# Access Compliance Report

## Public Rights-of-Way

### (Curb Ramps)

Intersection ID: 6029	Main Street: PIMPERNEL_RD	Cross Street: ROSEMALLOW_RD	Location: NW
ADA ID: 2D50A1A25E72	Ramp Type: Perp	Initial Pass/Fail: Fail	Overall Compliance: No
		Severity Score: 25

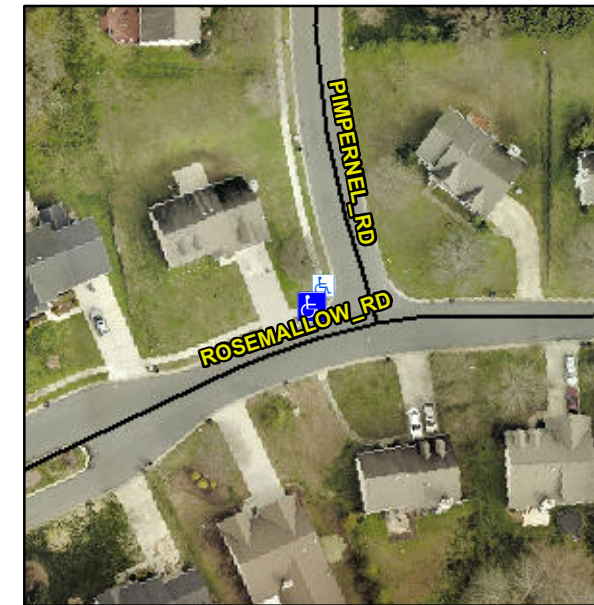
**Not Found, R304.5.3**

Compliance	Description	Data	Compliance	Description	Data
N/A	Ramp Length (in)	55.1	Yes	Ramp Slope (%)	5.3
Yes	Ramp Width (in)	80.0	No	Ramp XSlope (%)	11.2
N/A	Flare Type LT	N/A	N/A	Flare Type RT	N/A
N/A	Flare Slope LT (%)	N/A	N/A	Flare Slope RT (%)	N/A
N/A	Flare Traversable LT?	N/A	N/A	Flare Traversable RT?	N/A
N/A	Landing Length (in)	N/A	N/A	DWS Provided?	N/A
N/A	Landing Width (in)	N/A	N/A	DWS Contrast?	N/A
N/A	Landing Slope (%)	N/A	N/A	DWS Length (in)	N/A
N/A	Landing X Slope (%)	N/A	N/A	DWS Full Width?	N/A
N/A	Landing Curb? (Y/N)	N/A	N/A	DWS Offset (in)	N/A
N/A	Shared Landing?	N/A			
N/A	Gutter Ponding?	N/A	N/A	Gutter Slope (%)	N/A
N/A	Gutter Lip Ht (in)	2.0	N/A	Gutter X Slope (%)	N/A
N/A	Painted X Walk1?	No	N/A	Painted X Walk2?	N/A
	X Walk 1 Direction	To S		X Walk 2 Direction	N/A
N/A	X Walk 1 Width (in)	N/A	N/A	X Walk 2 Width (in)	N/A
	X Walk 1 Slope (%)	0.2		X Walk 2 Slope (%)	N/A
	X Walk 1 X Slope (%)	7.3		X Walk 2 X Slope (%)	N/A

**Remove & Replace Entire Ramp.**
